Certificate of Appropriateness

1534 N. Farwell Paul Weise Building

General rehabilitation of the building with 1) new entrance awning on Farwell and removal of all fabric awnings, 2) replacement of storefront plate glass windows, 3) restoration of storefront transom windows 4) brick cleaning and repointing where appropriate 5) brick repainting/touch up where already painted, 6) insert four windows on rear elevation, 7) a rear addition for accessibility and additional egress paths, 8) modest rooftop penthouse with pergola.

Canopy Detail View

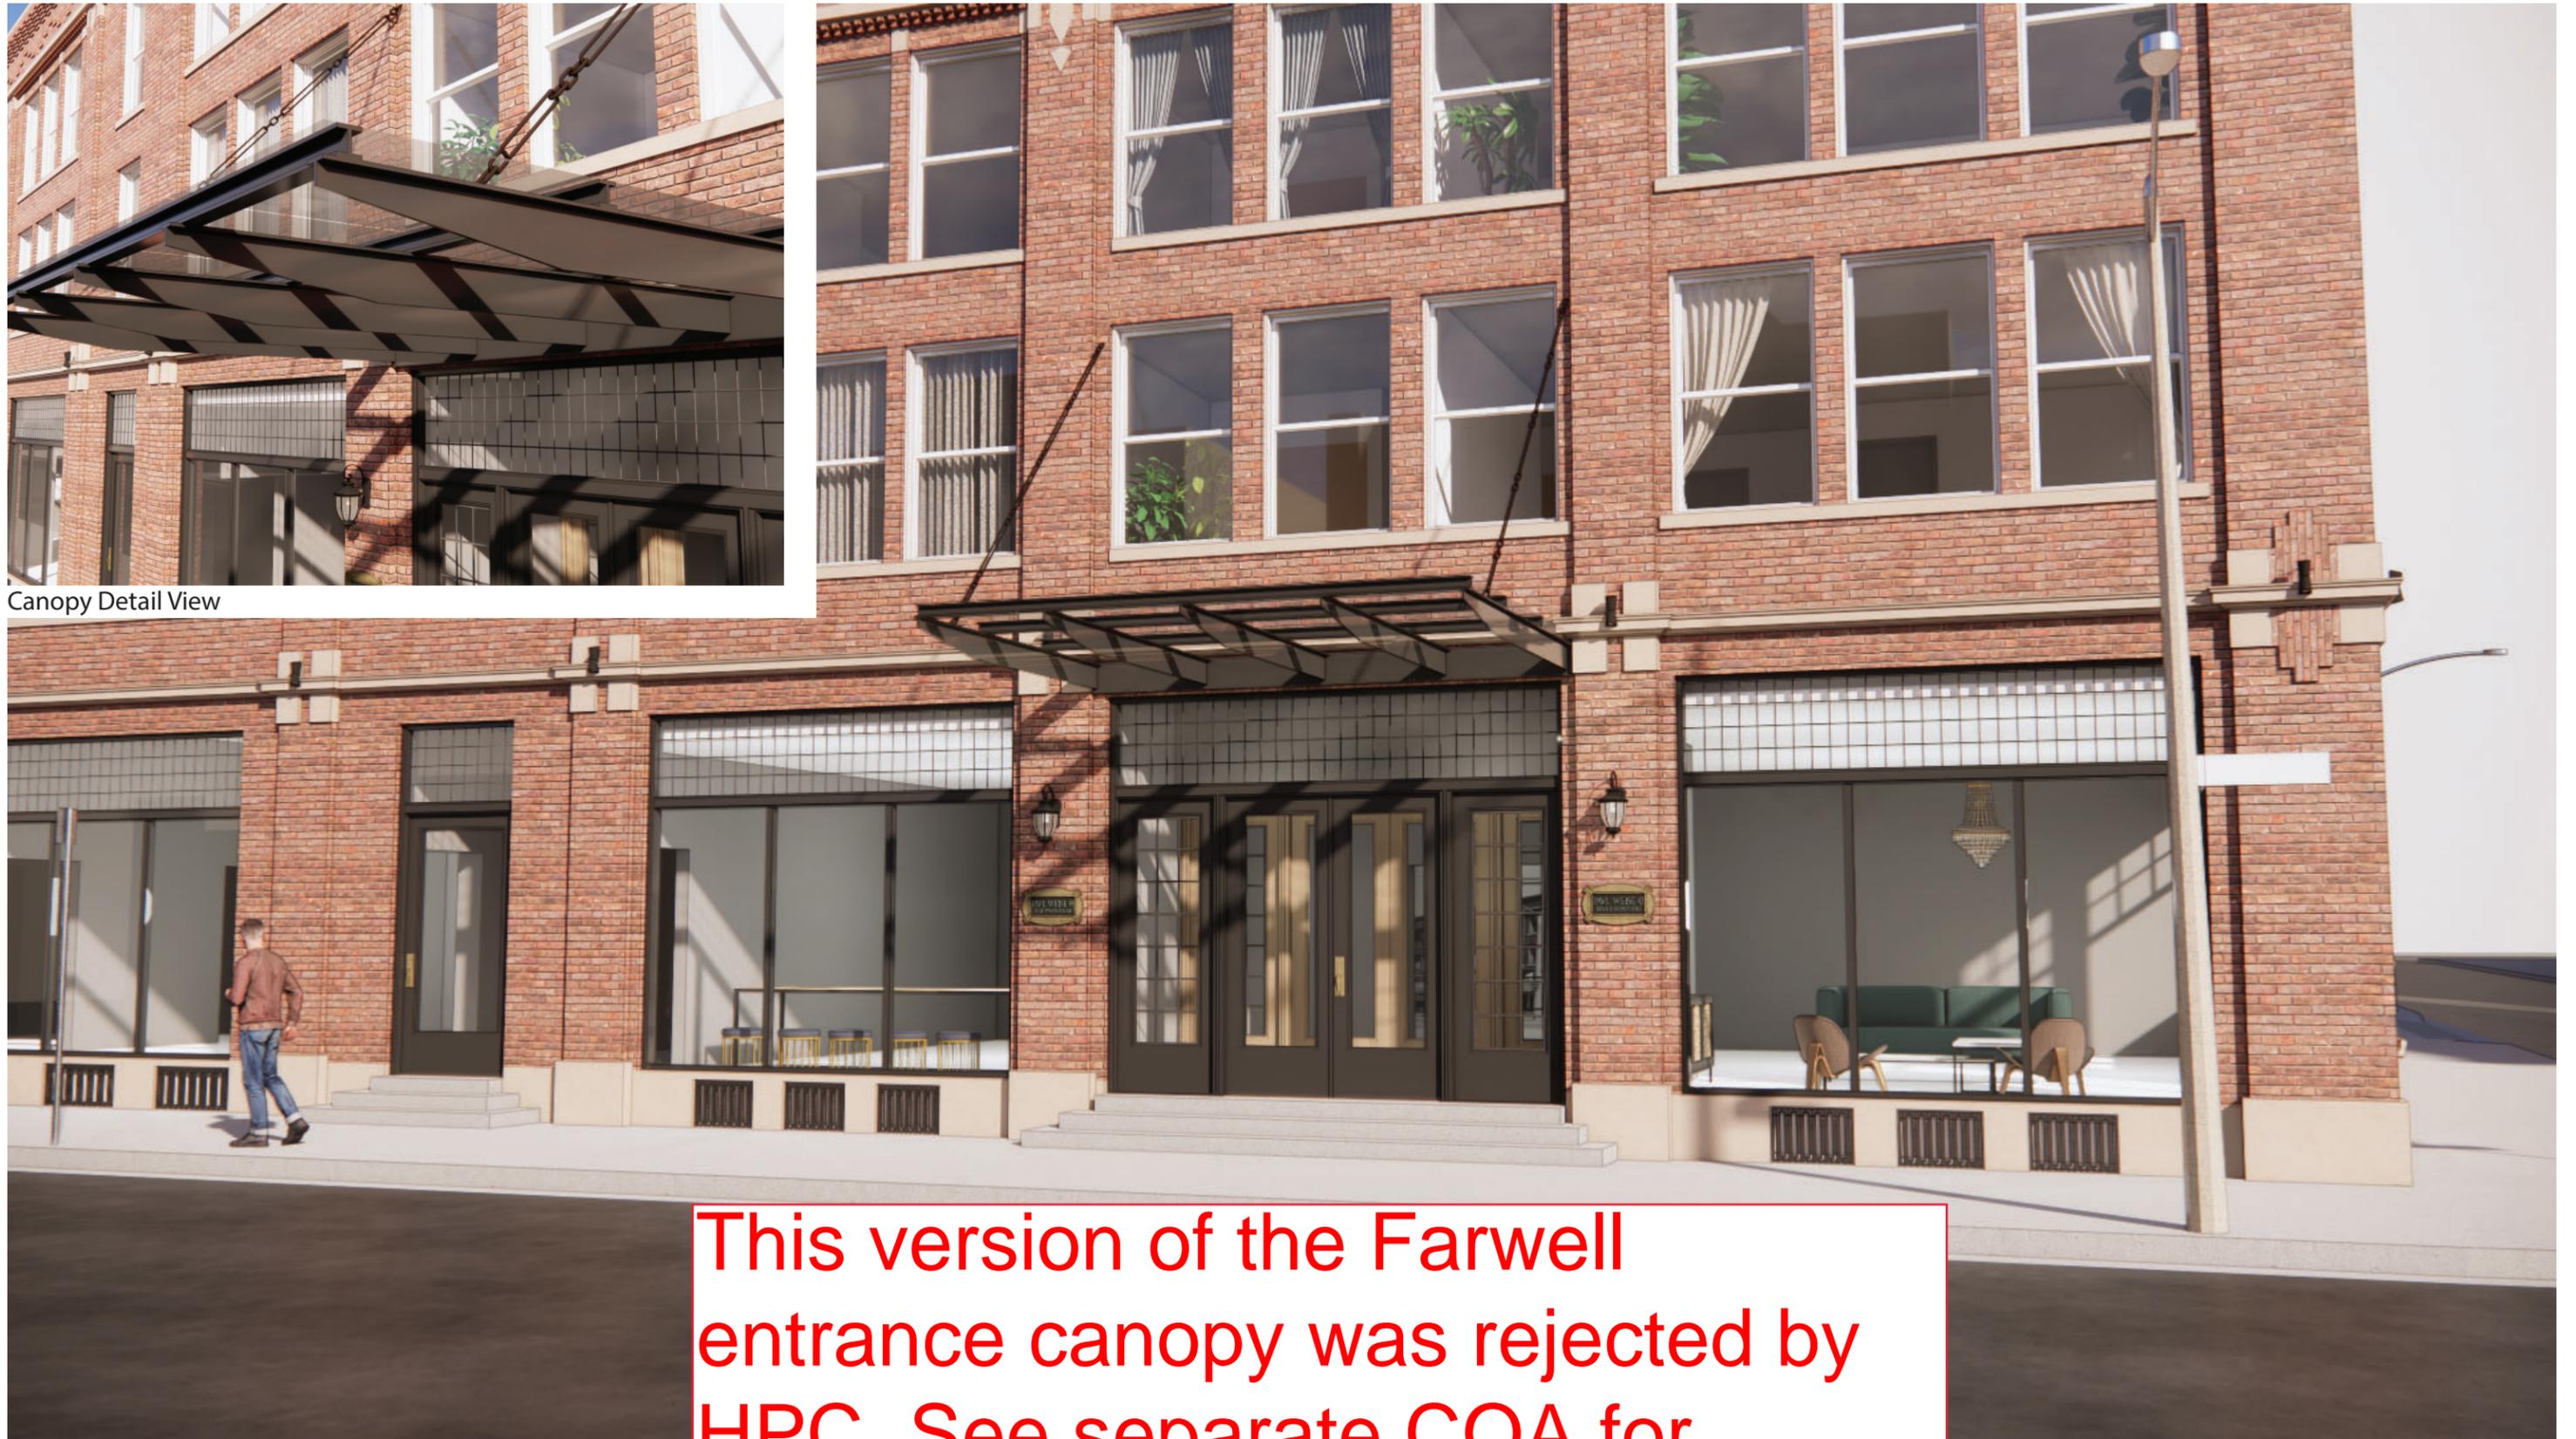
This version of the Farwell entrance canopy was rejected by HPC. See separate COA for Farwell canopy.

Approved as drawn with the exception of conditions below and metal canopy at main entrance on Farwell. *The Farwell metal canopy has been approved in a separate document in a NEW design.*
